**Title: Miscellaneous Revisions, Clarifications, and Corrections****S-100 Maintenance - Change Proposal Form (Draft)**

<b>Organisation</b>	Raphael Malyankar	<b>Date</b>	11-Feb-2019
<b>Contact</b>	Raphael Malyankar	<b>Email</b>	raphaelm@portolansciences.com

No.	S-100 Version No.	Part No.	Section No.	Proposal Summary
1	4.0.0	App. 4a-D	Figure 4a-D-2 and Table S100_DatasetDiscoveryMetadata	Specify that the relationship between S100_DatasetDiscoveryMetadata and S100_SupportFileDiscoveryMetadata is by reference.
2		App. 5-A 10b	Figure 5-A-1 Table 5-A-15	Listed value needs an abbreviated camel case alphaCode as well as the numeric code, for use in XML-based encodings. The IHO GI registry already includes this field for listed values.  Data format may need to indicate whether it is using the alphaCode, label, or the numeric code. This can be managed with an additional dataset information attribute in the
3		2b	4.2.17	Add Remark: Format RRGGBB, range of each component is [00, FF]. The preview_sRGB is just used by the portrayal register and catalogue builder to give a sample of what the colour looks like. The actual colour value used for portrayal depends on the active colour palette.

### **Add alpha code to listed values in feature catalogue:**

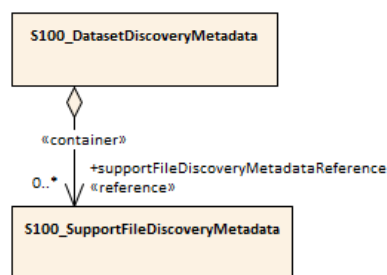
The use of camel case alpha code for listed values allows encodings to use short, human-friendly mnemonic alpha codes for attribute values in datasets instead of labels (which are often quite long and may also have punctuation and whitespace). These codes can also be used as keys in lookup tables and dictionaries to link listed value labels, numeric and alpha codes, and descriptions. They play the same role for listed values that the camel case code plays for features, information types, and attributes.

[Replace S100\_FC\_ListedValue in Figure 5-A-1 with the following fragment and update Table 5A-15 with the description of the added attribute.]

S100_FC_ListedValue	
+	label: CharacterString
+	definition: CharacterString
+	code: PositiveInteger
+	remarks: CharacterString [0..1]
+	alias: CharacterString [0..*]
+	alphaCode: CharacterString

Role name	Name	Description	Mult.	Type	Remarks
Attribute	alphaCode	Alpha (camel case) code of listed value	1	CharacterString

Figure 4a-D-2 in Edition 4.0.0

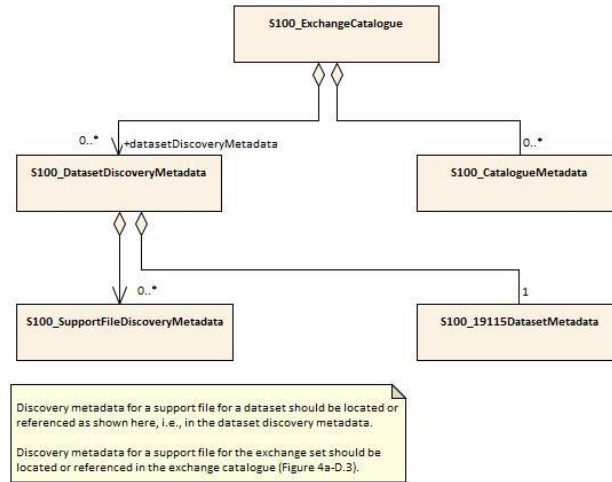
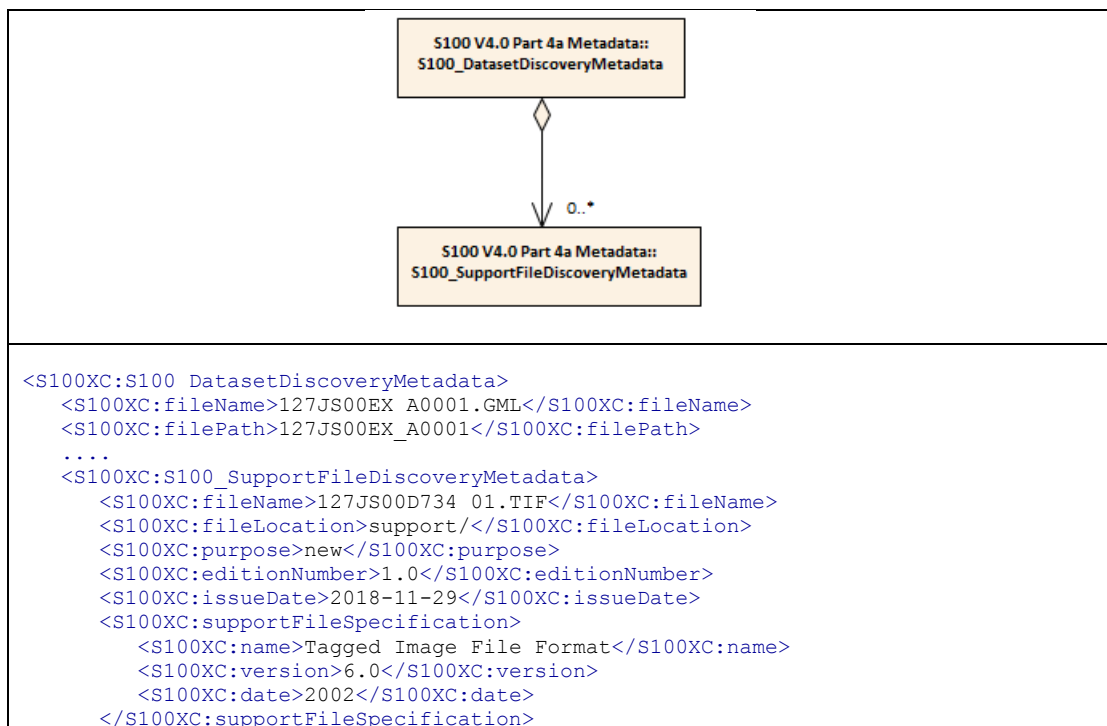
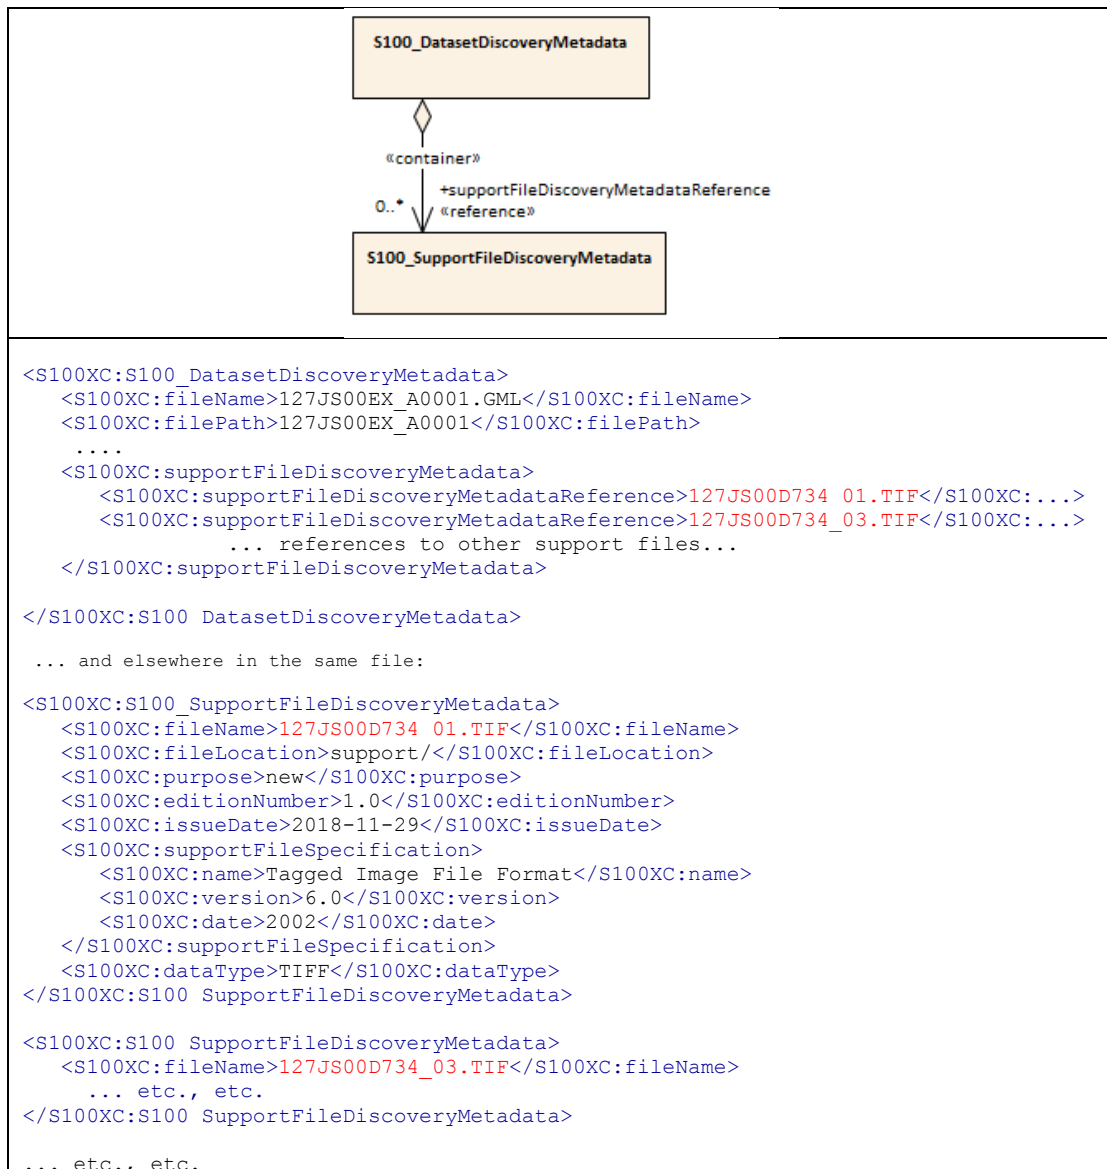
Figures 4a-D-2 and 4a-D-4 depict the relationship between S100\_DatasetDiscoveryMetadata and S100\_SupportFileDiscoveryMetadata as an aggregation that is navigable from the dataset metadata to the support file metadata element. The current Figure 4a-D-2 is shown below.

The relationship between dataset and support file discovery metadata is converted by Enterprise Architect to a containment relationship in the corresponding XML schema (i.e., the support file XML element is nested inside the dataset discovery element). The relevant extract from Figure 4a-D-2 is depicted below along with an example of the XML metadata. Edition 4.0.0 named the role **supportFileDiscoveryMetadata** in the table on page 30 of Part 4a (not shown in Figure 4a-D-2). The resulting XML is shown below the UML extract. (The generic S-100 XML schema for the exchange catalogue in S-100 Edition 4.0.0 was manually modified to allow either containment or reference relationship.)

It is proposed to specify in Figure 4a-D-2 that the support file discovery metadata be linked to dataset discovery metadata by means of a reference, indicated by adding the «reference» stereotype to the role name.

It may also be convenient for implementations to have all the references contained inside a container element – this is depicted by the «container» stereotype on the aggregation itself. The name of the container element (supportFileDiscoveryMetadata) and its multiplicity are specified in the documentation table.
